CITY OF YPSILANTI
Agenda
Historic District Commission
Tuesday, November 28, 2017 - 7:00 p.m.
Senior Center, 1015 N Congress St
Ypsilanti, MI 48197

HDC Work Permit Staff Review

Property address: 205 N Hamilton

Material List- 31 N Washington, Ypsilanti

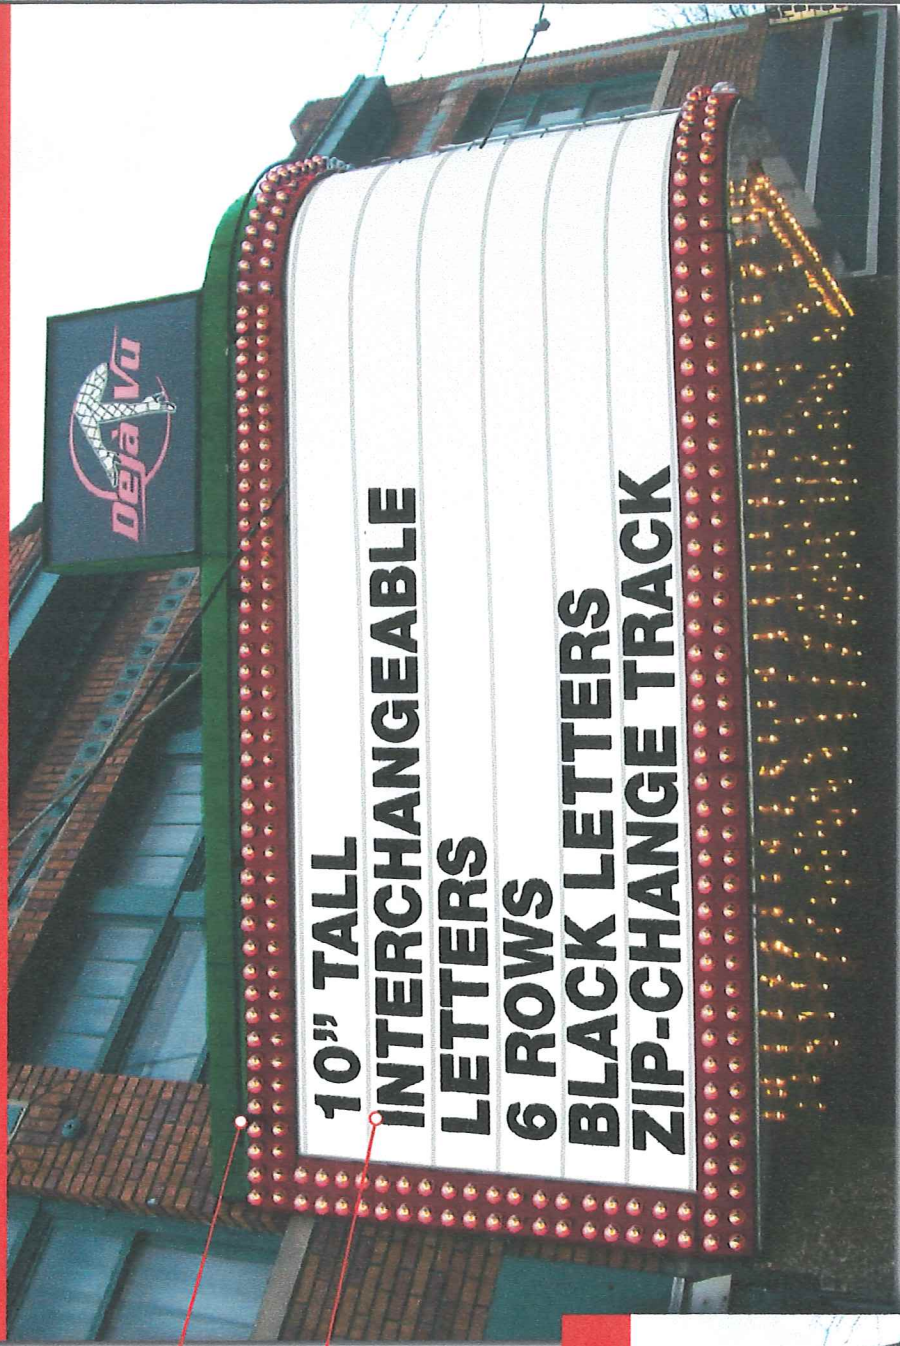
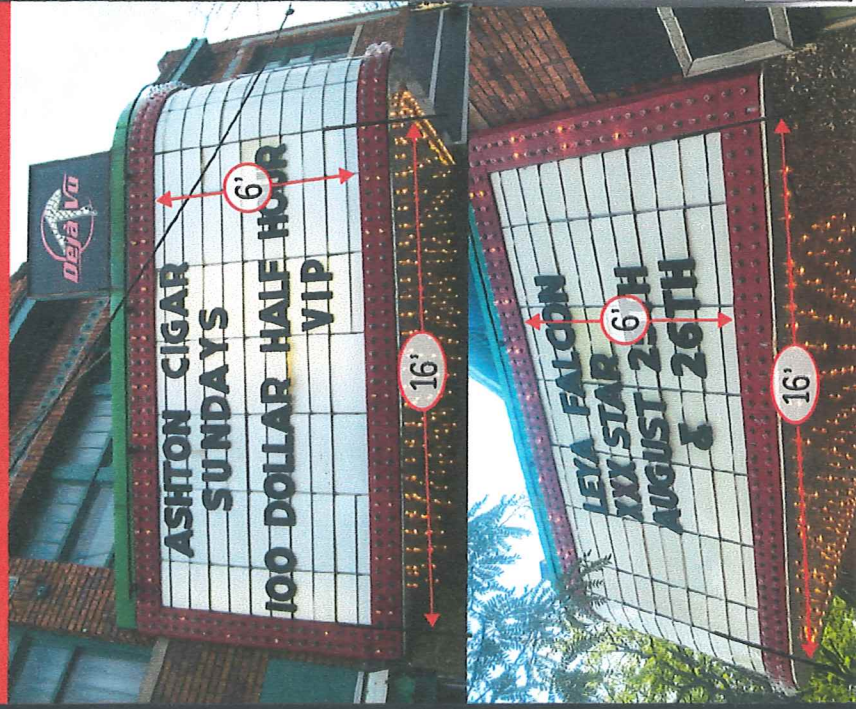
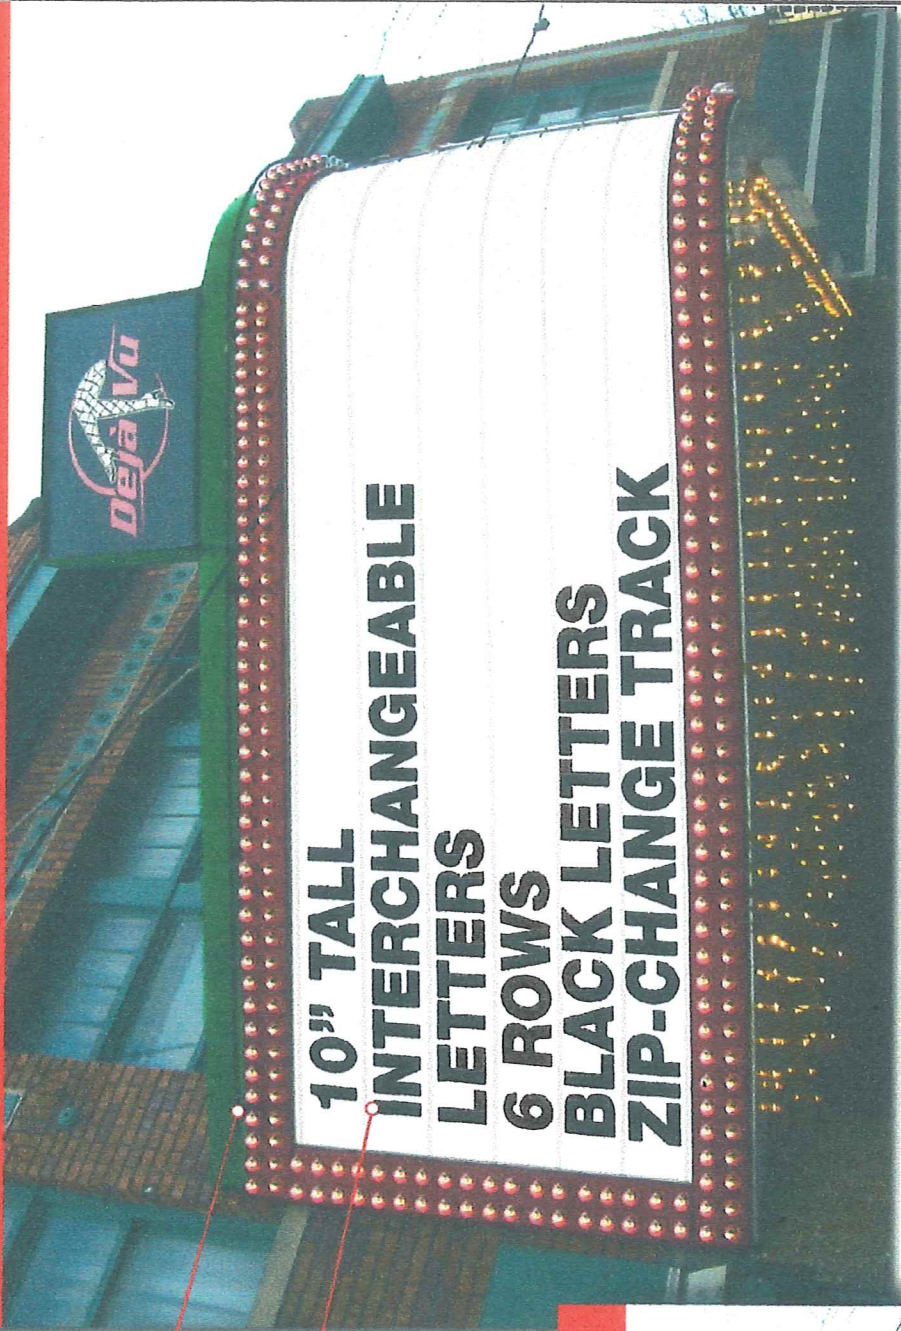
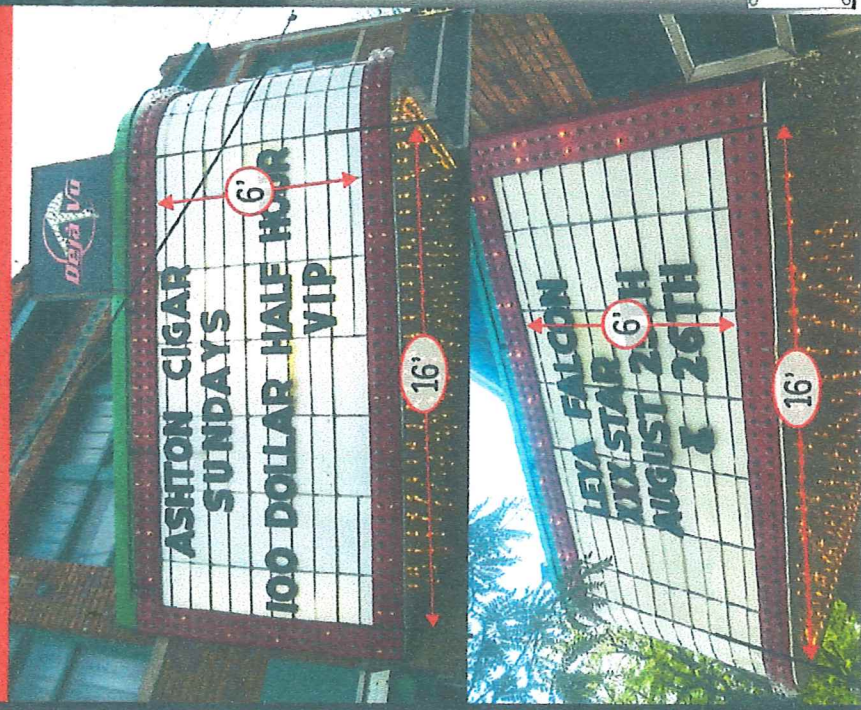
4. The applicant is planning on cleaning and painting the marquee sign. The replacement of the tracks for the lettering and an updating of the lighting to LEDs is planned.

Move to approve the work at 29-31 N Washington to include the cleaning and painting the marquee sign. Paint to match the existing. Work to also include the replacement of the tracks for the lettering to clear tracks to accommodate 10" letters. The LED lights for the exterior will be the nostalgic S14 bulbs and the interior lights will be updated with LEDs. All lighting to comply with the HDC lighting fact sheet.
